EPA Response to Comments

Response to Public Comments

**Class III Area Permit No. SD31231-00000, Aquifer Exemption Decision
And
Class V Area Permit No. SD52173-00000**

**Powertech (USA) Inc.
P.O. Box 448
Edgemont, South Dakota 57735**

Figure A. Gott et al., 1974, Plate 2 showing the extent of the Dewey Fault and Structural Zone with the Dewey-Burdock Project Area superimposed.

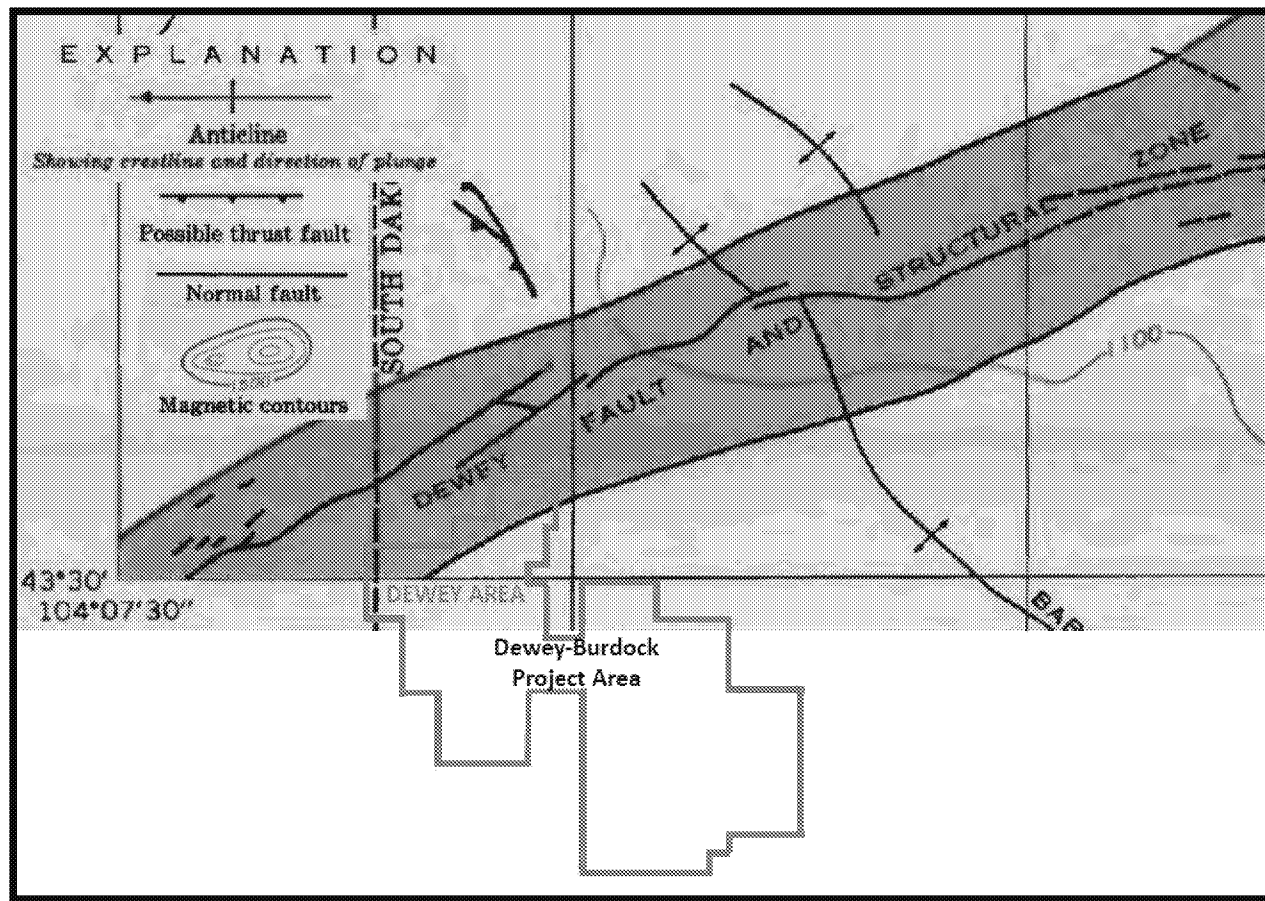
There is no evidence of the Dewey fault inside the project area. (Brobst, 1961, *Geology of the Dewey Quadrangle Wyoming-South Dakota*, USGS Bulletin 1063-B.) Brobst, 1961, describes the Dewey Fault in the Dewey quadrangle geologic report as the fault passing through the town of Dewey and refers to the fault located to the southeast without a name. Braddock, 1963, does not refer to more than one fault plane related to the Dewey Fault in the Geology of the Jewel Cave SW quadrangle report (Braddock, W.A., 1963, *Geology of the Jewel Cave SW quadrangle Custer County, South Dakota*, USGS Bull 1063-G). Gott, et al., 1974, includes both faults described by Brobst, 1961, in the Dewey Fault and Structural Zone. The boundaries of this structural zone are shown in Plates 2 and 4 of the Gott et al., 1974 report. The extent of the Dewey Fault and Structural Zone as defined by Gott in Plate 2 near the Dewey-Burdock Project Site is shown in Figure A. The Dewey-Burdock Project Site Boundary is superimposed on Plate 2. Although Gott shows the Dewey Fault and Structural Zone as extending into the northwestern edge of the Dewey-Burdock Project Site, there is no evidence of any fault inside the Project Area.

Figure B. Excerpt from Gott et al., 2001, Plate 4 showing features inside the Dewey-Burdock Project Boundary.

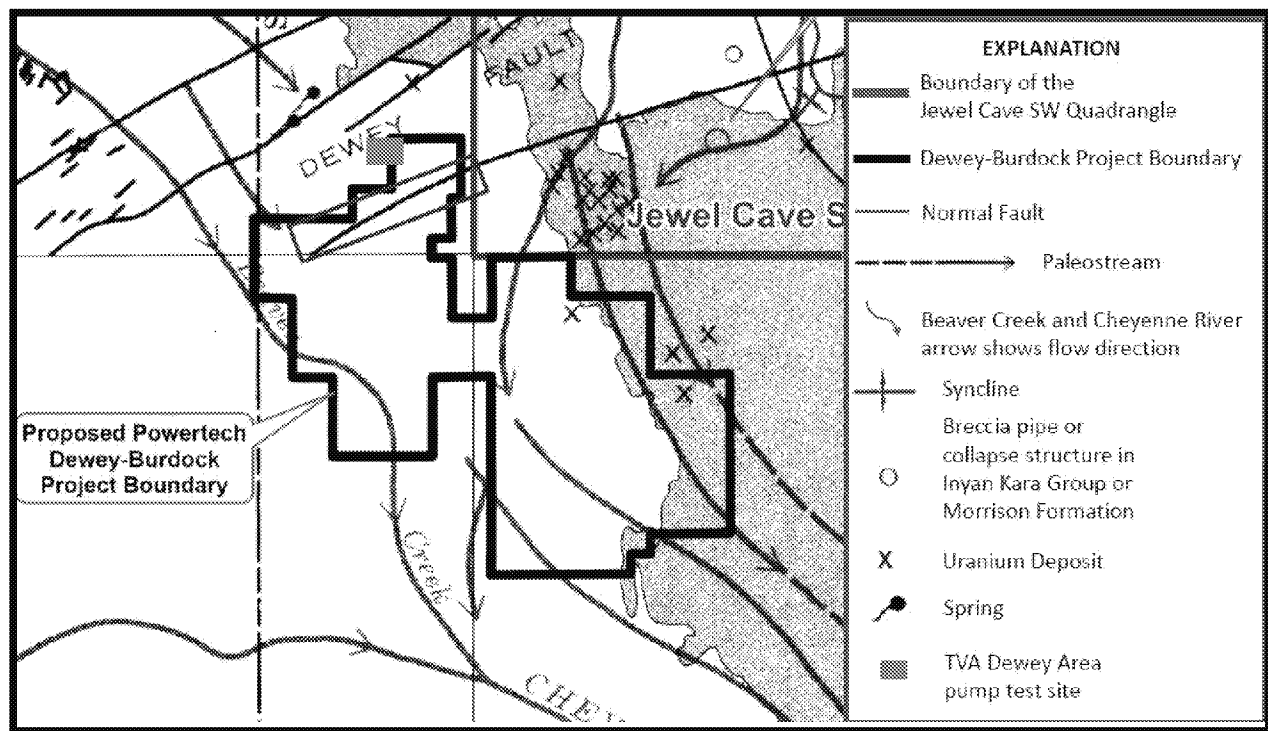
A commenter referred to Plate 4 from Gott et al., 1974, as the Gott fault map. Powertech used Plate 4 as a base map for Plate 6.24 of the Class III Permit Application and superimposed the Dewey-Burdock Project Boundary to show where the collapse features and breccia pipes identified in Gott et al., 1974, are located relative to the Project Site. Plate 6.24 shows that none of these features are located inside the Project Area. Figure B is an excerpt from Plate 6.24. The features shown inside the project boundary are Beaver Creek and paleostreams. The linear feature in the red box inside the Dewey-Burdock Project Area is the southeast boundary of the Dewey-Fault and Structural Zone shown in Plate 2.

EPA disagrees with the commenter's statement that the features in Plate 4 demonstrate that EPA failed to conduct the necessary physical surveys to confirm or deny the presence of these geological features. Based on the discussion above regarding the features identified in Plate 4 within the Project Area, there is no need for EPA to perform a physical survey because no disruption of confining zones in the currently proposed wellfield areas is indicated by the information in Plate 4.

Figure C. Dewey wellfield locations relative to the possible normal fault location in the Dewey-Burdock Project Boundary.

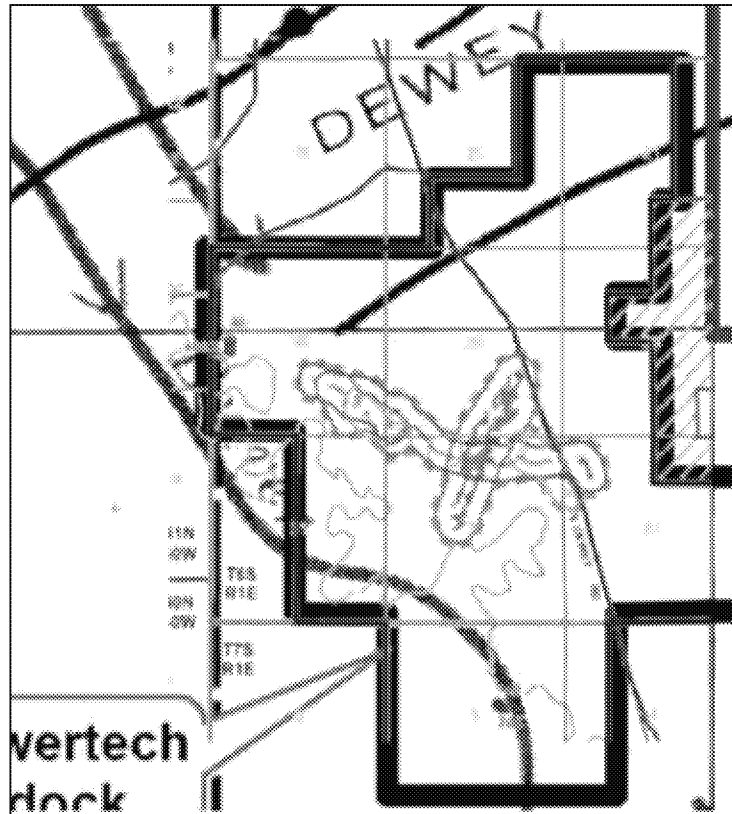
Figure C shows that the southeastern edge of the Dewey Fault and Structural Zone does not intersect the proposed wellfields in the Dewey Area, so it is not of concern for the currently proposed for ISR operations. The fact that the Dewey Fault and Structural Zone is located upgradient of the Dewey wellfields and the inward hydraulic gradient required for each wellfield will prevent ISR injection interval fluids from migrating to the location of this zone. If Powertech proposes future wellfields in this area, correlation of drillhole data in the area would identify any offset of geologic strata caused by the presence of a fault.

Figure D. Potentiometric surface contour maps of the Fall River and Chilson aquifer from Figures 5.2 and 5.3 of the Class III Permit Application.

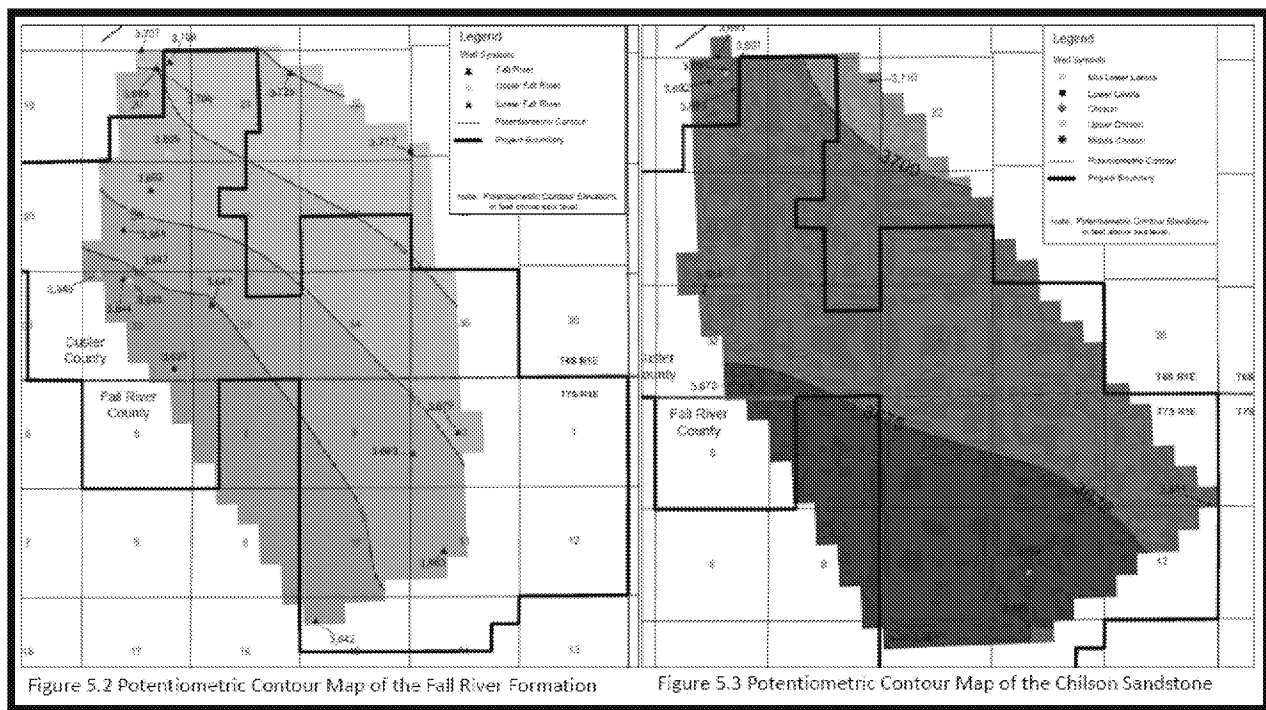
EPA disagrees with the interpretation that the potentiometric surface of the Fall River aquifer and the Chilson aquifer being at similar elevations in the vicinity of wellfields 6, 7 and 8 indicates leakage through the Fuson confining zone in this area. Figure D shows the potentiometric surface contours of the Fall River and Chilson aquifer based on water level measurements in wells completed in each aquifer.

These maps show that the potentiometric surface of the Fall River aquifer is at a higher elevation than that of the Chilson in the northeastern portion of the project area. The Chilson aquifer potentiometric surface is at a higher elevation than that of the Fall River aquifer in the southwestern portion of the project area. At some point these potentiometric surface elevations are at the same elevation, as demonstrated by the cross-sections shown in Plates 6.13 and 6.14 of the Class III Permit Application. EPA concludes that this is the reason for the similarity in elevation of the Fall River and Chilson potentiometric surfaces in the vicinity of Burdock Wellfields 6, 7 and 8.

Figure E. Areas of the Inyan Kara Group aquifers approved by this Record of Decision.

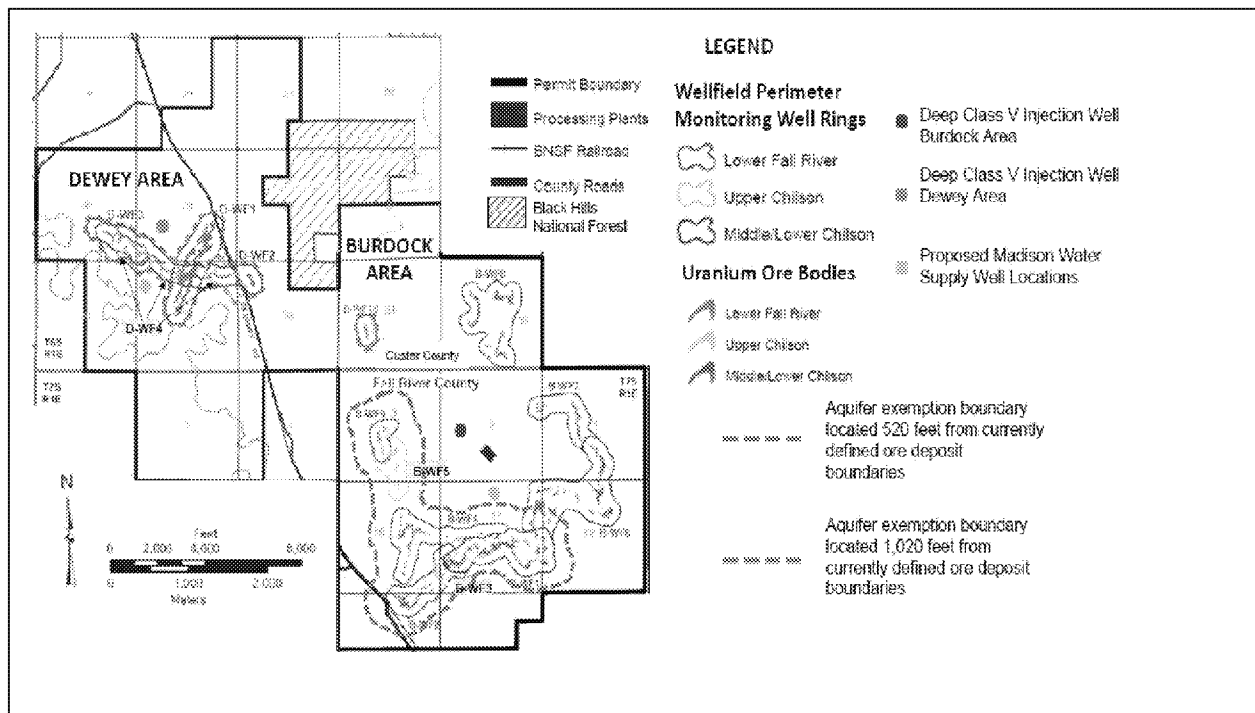
Powertech requested an expanded AE area to accommodate additional ore resources identified after the Class III Permit Application was submitted. EPA reviewed the Preliminary Economic Assessment reports developed by consultants documenting independent audits of mineral resource estimates at the Dewey-Burdock Project Site and determined that the commercially producible ore resource boundary had expanded in Burdock Wellfields 1 through 5, 9 and 10 since Powertech submitted the Class III Permit Application, justifying expanding the AE boundary for these wellfields. However, the commercially producible ore resource boundaries had not expanded for the other wellfields, so EPA did not expand the AE boundaries for these other wellfields. Because Powertech needs to do additional work to demonstrate that the potentiometric surfaces in Burdock Wellfields 6, 7 and 8 are able to sustain adequate monitoring of ISR operations in the overlying Upper Chilson aquifer, EPA is postponing approval the aquifer exemption in the area of Burdock Wellfields 6, 7 and 8 until Powertech performs further aquifer testing in that area.

Figure F. Minnelusa aquifer groundwater flow direction map from Figure 17, Driscoll et al., 2002.

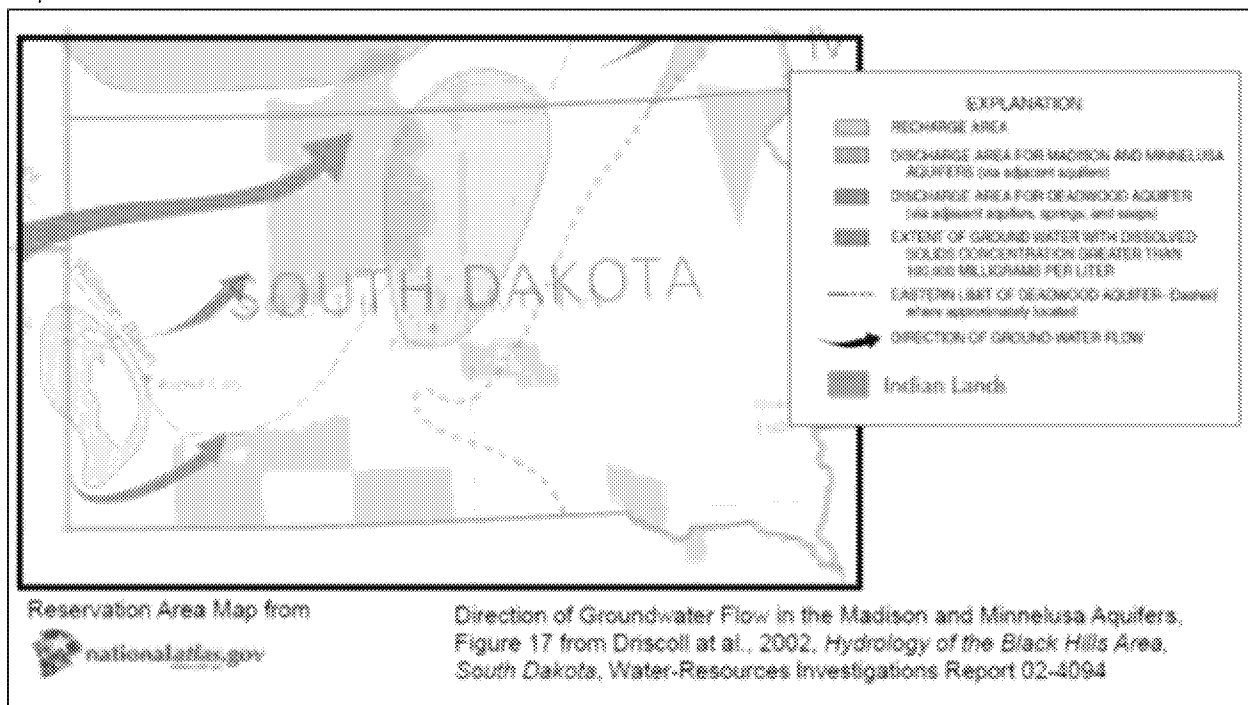
EPA investigated groundwater flow directions in the Minnelusa aquifer at the Dewey-Burdock Project Site and at the springs, such as Cascade Springs, south of the Black Hills. Figure F is a groundwater flow direction map from Figure 17 in Driscoll et al., 2002. This map shows the direction of groundwater flow in the Minnelusa aquifer from its recharge area in the Black Hills to a discharge area located at the eastern edge of the Cheyenne River Reservation. As shown in the map in Figure F, the authors hypothesize that the Minnelusa aquifer groundwater flows from the Dewey-Burdock site and flows around the southern end of the Black Hills toward the Williston Basin. (Driscoll, D.G., et al., 2002, *Hydrology of the Black Hills Area, South Dakota*, USGS Water-Resources Investigations Report 02-4094 at 22)

Figure G. Minnelusa aquifer potentiometric surface elevation contours in the area where springs occur south of the Black Hills (from Sheet 2, Strobel et al., 2000)

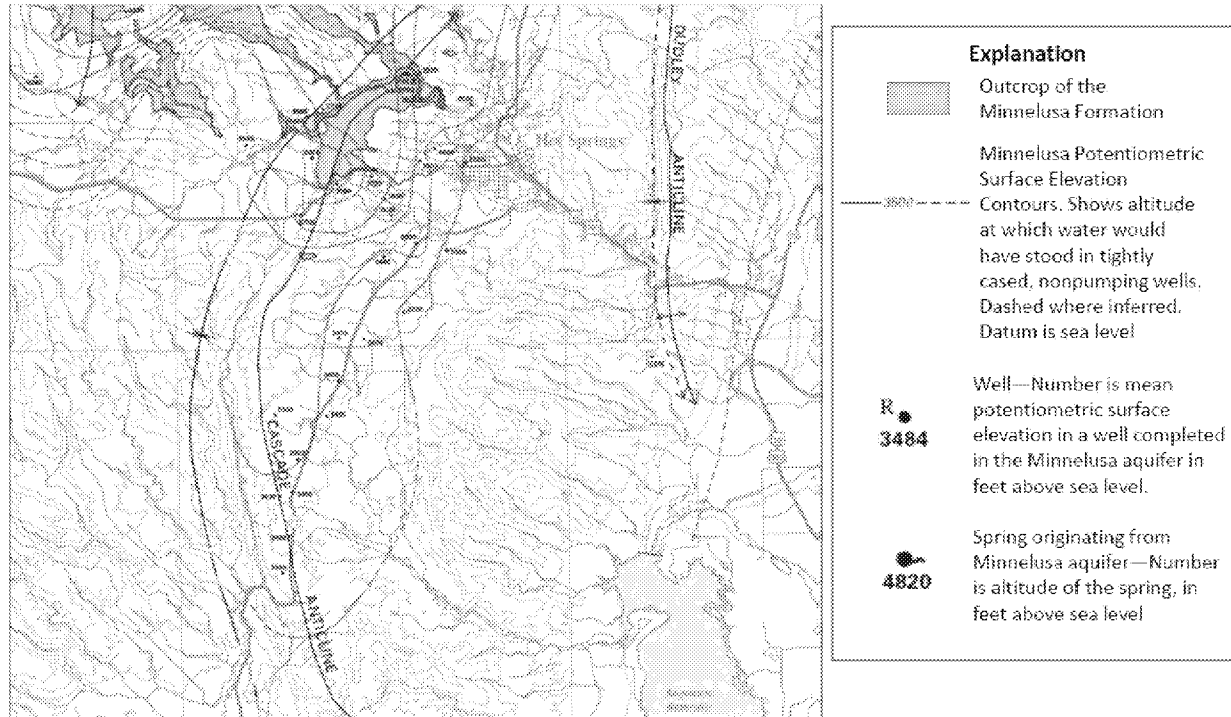
Figure G is the area where springs, including Cascade Springs, are located south of the Black Hills, excerpted from Sheet 2 of Strobel et al., 2000. The red lines show the potentiometric surface elevations based on wells completed in the Minnelusa and springs flowing from the Minnelusa. The potentiometric surface contours are deflected southward along the Cascade anticline where the Minnelusa and other geologic strata are raised in elevation. (Strobel et al., 2000)

Figure H. Elevation of the Minnelusa Formation top surface (Source: Sheet 2 of Carter and Redden, 1999)

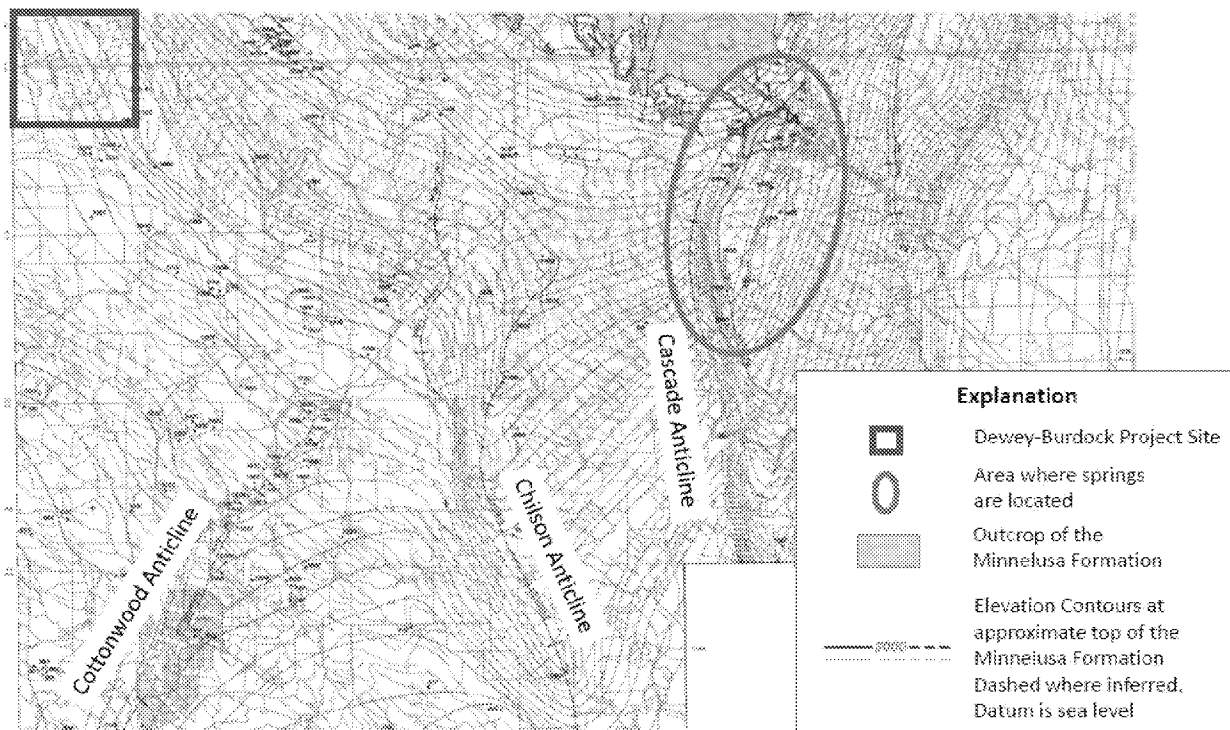
Figure H shows the area south of the Black Hills, excerpted from Sheet 2 of Carter and Redden, 1999. (Carter, J.M. and Redden, J.A., 1999, *Altitude of the Top of the Minnelusa Formation in the Black Hills Area, South Dakota*, USGS Hydrologic Investigations Atlas HA-744-C, Sheet 2) In this figure the red lines are elevation contours along the top of the Minnelusa Formation. The springs shown in Figure G are located inside the green oval. Based on the elevation of the top of the Minnelusa Formation shown in the area where springs occur south of the Black Hills, the top of the Minnelusa Formation is at a higher elevation at this location than at the Dewey-Burdock Project Site. Figure H shows how the Cottonwood, Chilson and Cascade anticlines affect the Minnelusa Formation elevation. The Class V injectate from the Dewey-Burdock site would have to flow uphill to reach the location of these springs. Based on the potentiometric surface contours in Figure G, the flow path of Class V injectate would be deflected to the south by the Chilson and Cascade anticlines and would have to flow uphill to reach these springs where Minnelusa and Madison groundwater flows to the surface.

Figure I. Locations of springs emanating from or passing through the Minnelusa aquifer, from Figure 29 of Naus et al., 2001.

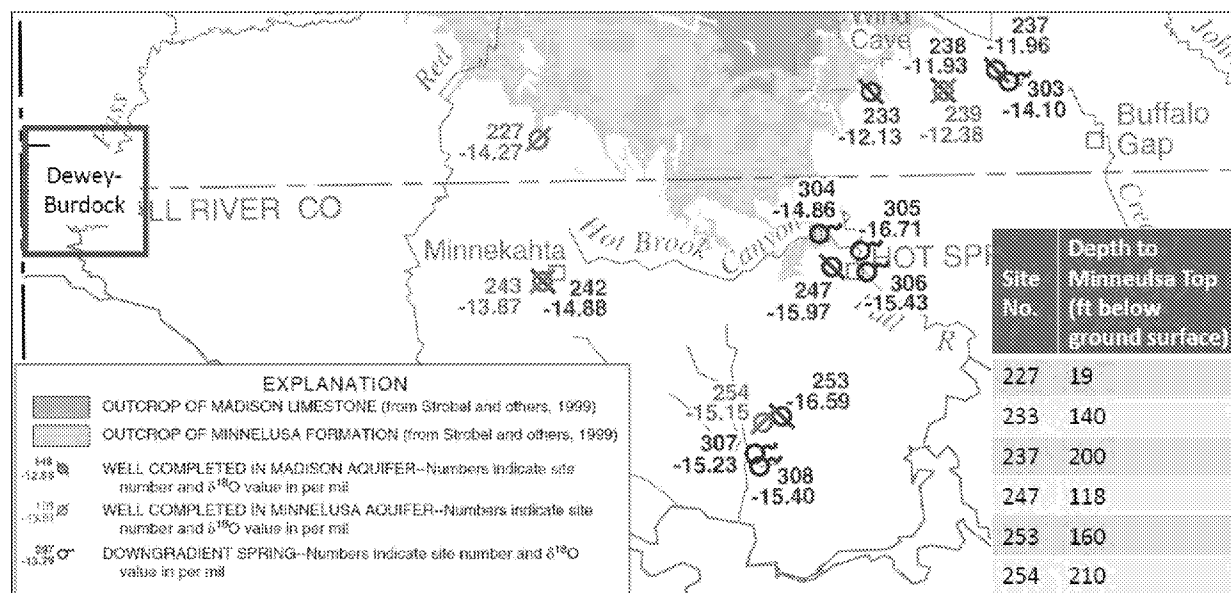
EPA reviewed water well logs in the area near the springs flowing from the Minnelusa and Madison aquifers. Figure I shows locations of Minnelusa (green) and Madison (red) wells and springs. The blue table in Figure I shows the depth to the top of the Minnelusa Formation in the logs for wells shown in Figure H. The springs occur where the top of the Minnelusa aquifer occurs closer to the ground surface. For example, at the location of the springs shown in Figure H the top of the Minnelusa is approximately 200 feet or less below ground surface, based on nearby private well logs.

Based on this analysis, EPA concludes that the Class V injectate will not contaminate the Madison aquifer and will not reach the area where the artesian springs are located.
